University Commons Project

Final Environmental Impact Report

Prepared for
City of Davis

May 2020

**Figure 4.6-3
Bicycle and Pedestrian Facilities – Existing Conditions**

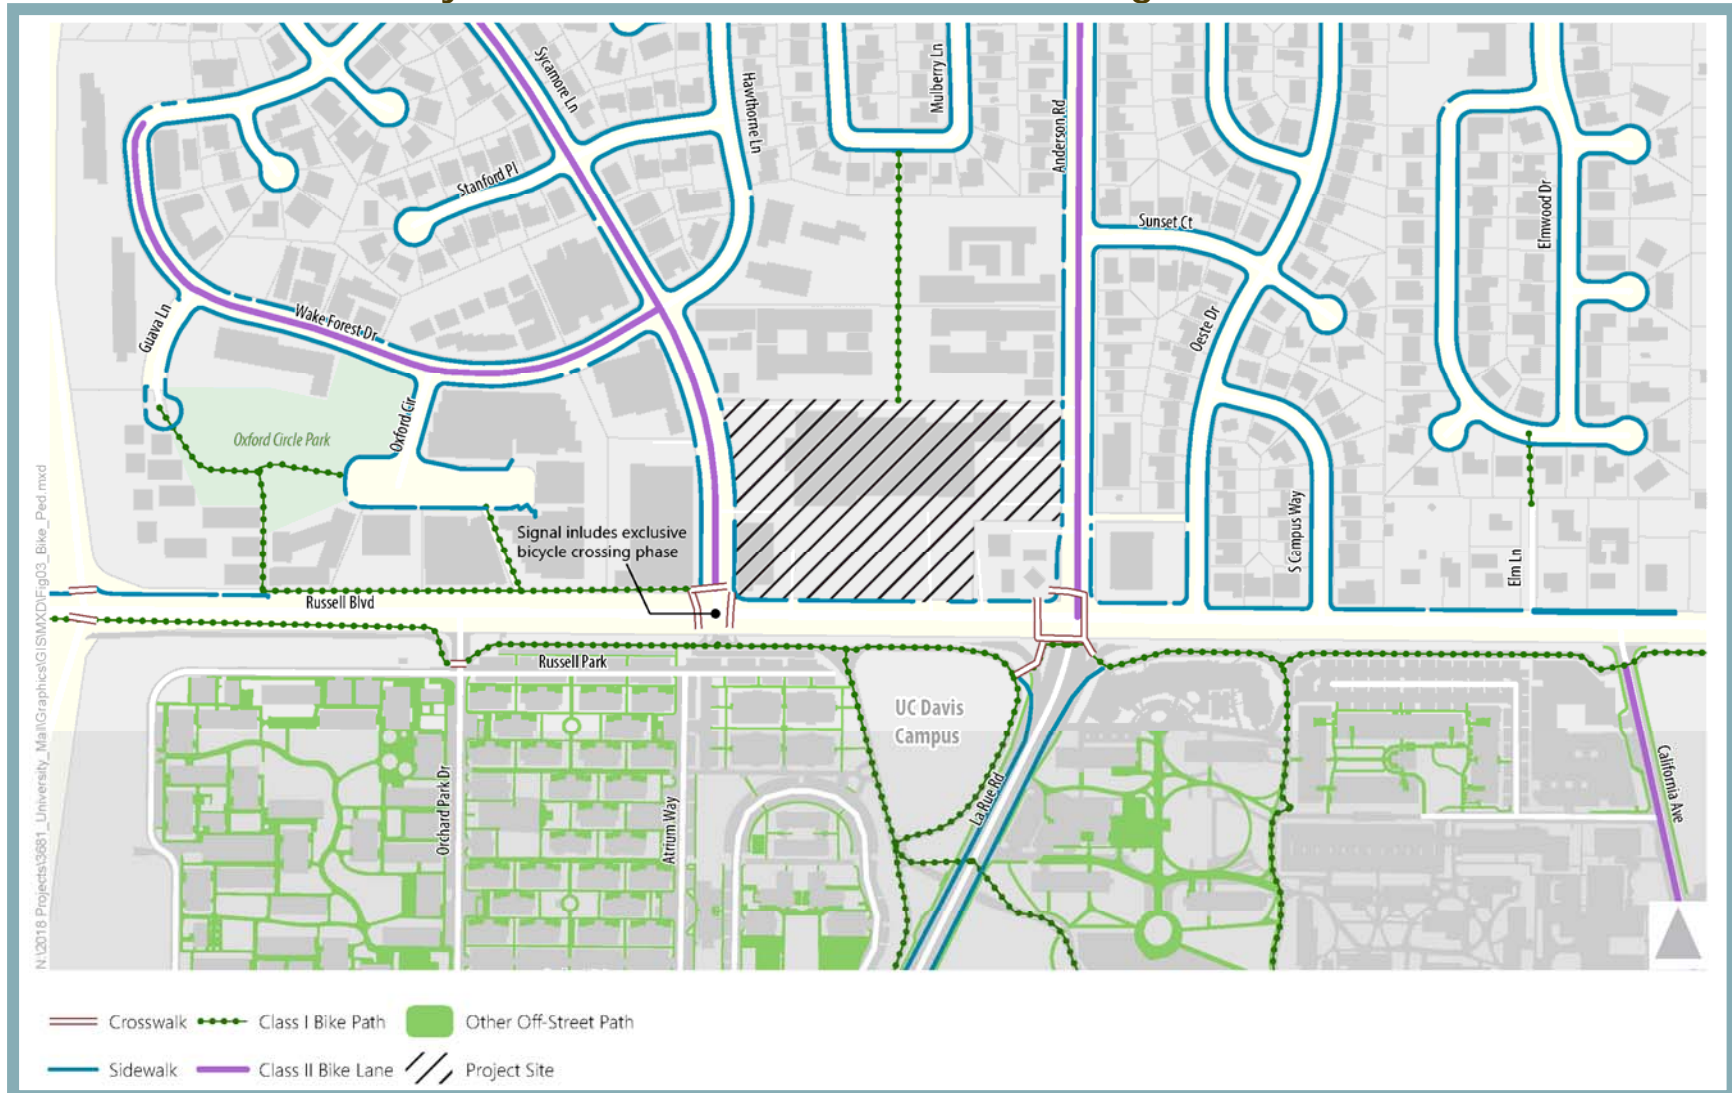
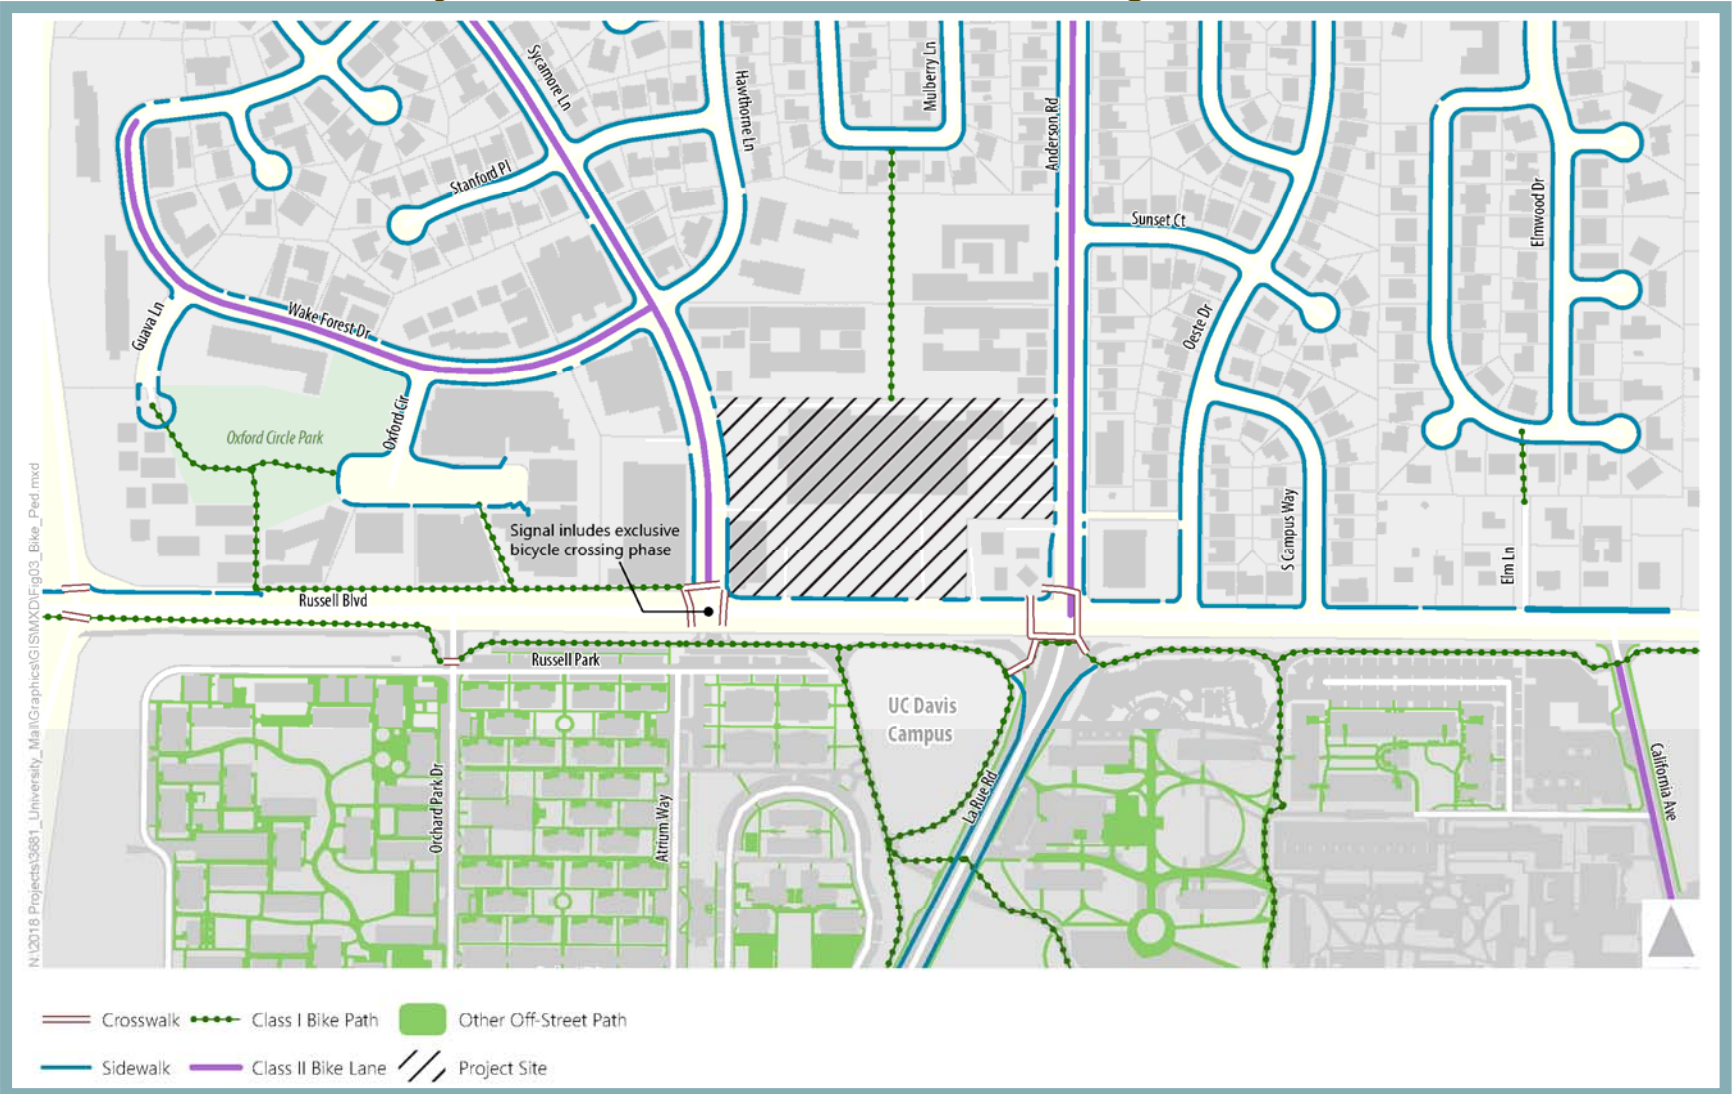
Figure 4.6-3: A Class I shared-use path connecting the site to Mulberry Lane is described on Page 4.6-9 but is not shown in the figure. This path is not currently suitable for heavy use, as it is rough and it joins Mulberry via a rolled curb without any additional curb cut.

The commenter states that an existing Class I shared-use path between the project site and Mulberry Lane is described on page 4.6-9 of the Draft EIR, but not shown on Figure 4.6-3 (Bicycle and Pedestrian Facilities – Existing Conditions). Figure 4.6-3 of the Draft EIR errantly omitted this Class I shared-use path. Accordingly, Figure 4.6-3 is hereby revised, as shown on the following page, to show the path. The revision is to correct a minor typographical error, and does not affect the adequacy of the Draft EIR.

Figure 4.6-3 on page 4.6-10 of the Draft EIR is hereby revised, as shown on the following page, to include an existing Class I shared-use path between the project site and Mulberry Lane that was errantly omitted from the version of the figure included in the Draft EIR. The revision is for clarification purposes only, and does not affect the analysis or conclusions of the Draft EIR.

**Figure 3-6
Proposed Building Levels**

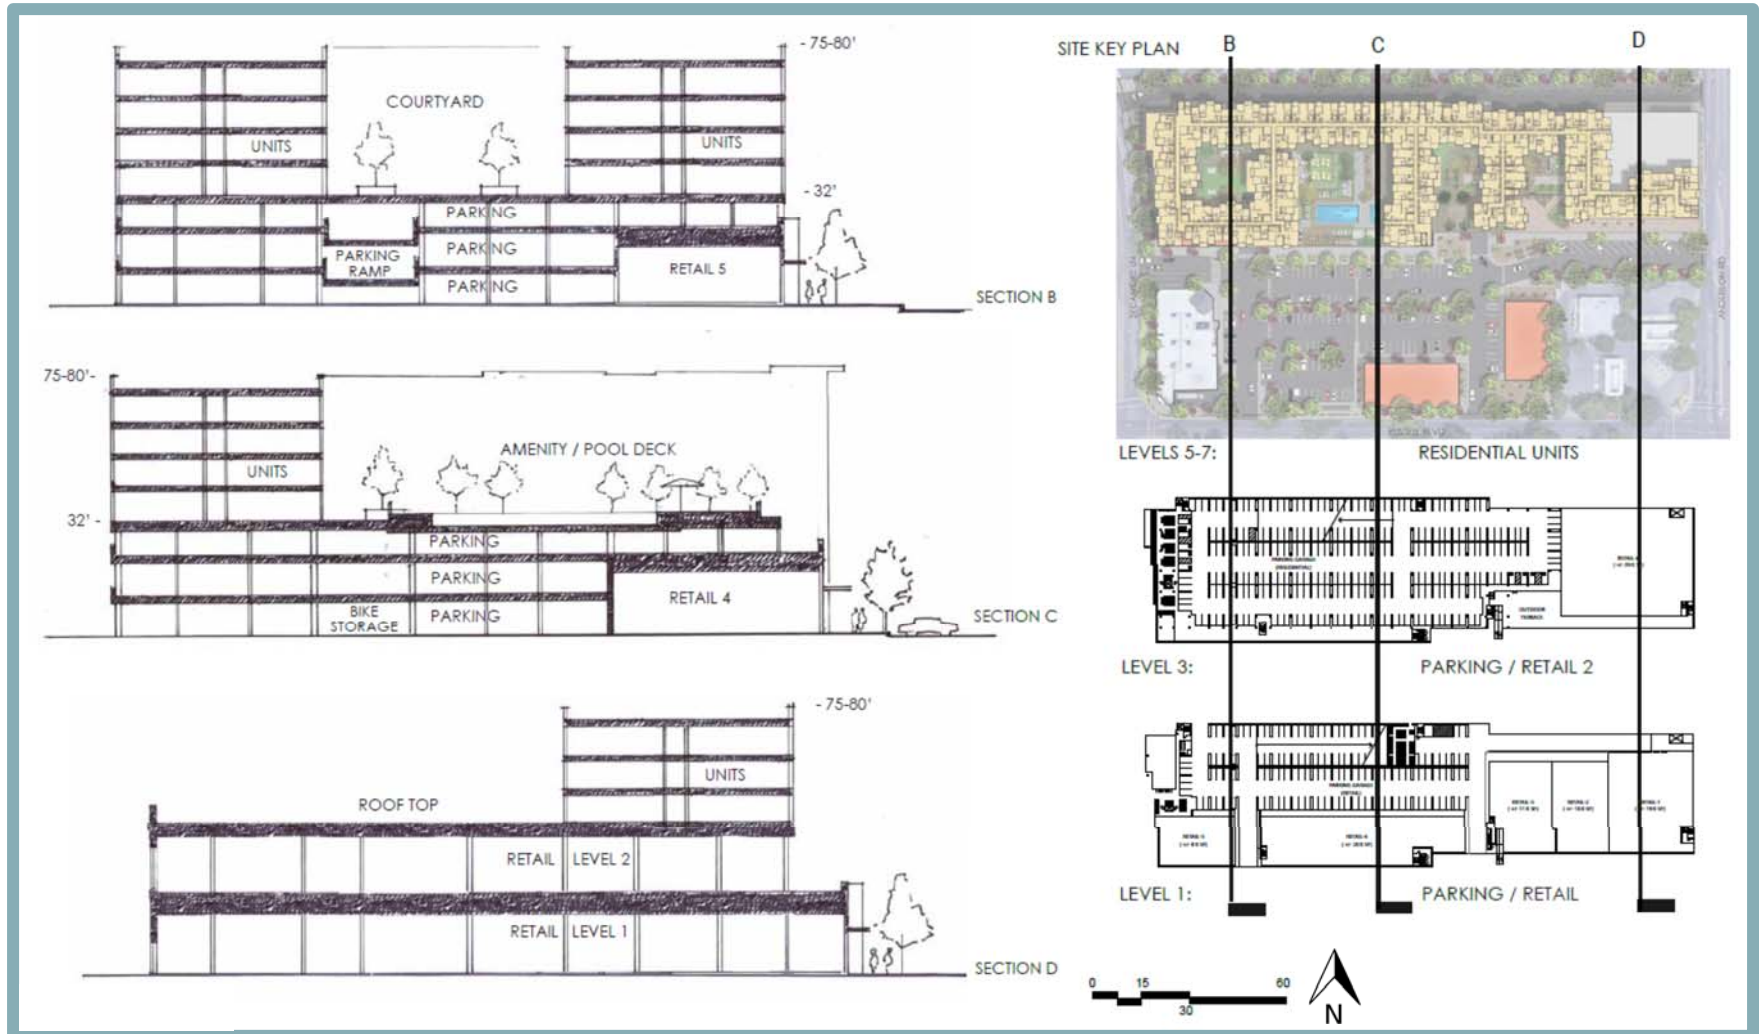
6-2 I have three specific concerns. First, I object to the plan to build a seven-story structure for University Commons. The seven stories planned for the complex is grossly out of proportion to the single-family homes in the adjacent neighborhood. I believe that the seven-story plan reflects the desire for profit by the developers rather than the interests of the residents of Davis. At the very least, the City of Davis should follow the guidelines laid out in the draft Downtown Davis Specific Plan. These call for limiting building heights to five-stories. Indeed, even a five-story building in the University Mall area is disproportionate to our neighborhood. I urge you to request the developers to submit a plan that is more in keeping with the neighborhood described above.

The proposed project structures would range in height, as show in Figure 3-6. At buildout, the redeveloped University Commons building would be seven stories and approximately 80 feet in height (see green outline in Figure 3-6), ~~with the northeast portion along Anderson Road stepping down to three stories and 44 feet in height (see blue outline in Figure 3-6).~~ It is important to note that the front façade of the seven-story building, as viewed from Russell Boulevard, would have articulation to help soften the appearance of the building. For example, the central portion of the building façade would consist of the amenity deck at a height of approximately 32 feet. The freestanding Retail 7 and 8 buildings would be approximately 32 feet in height.
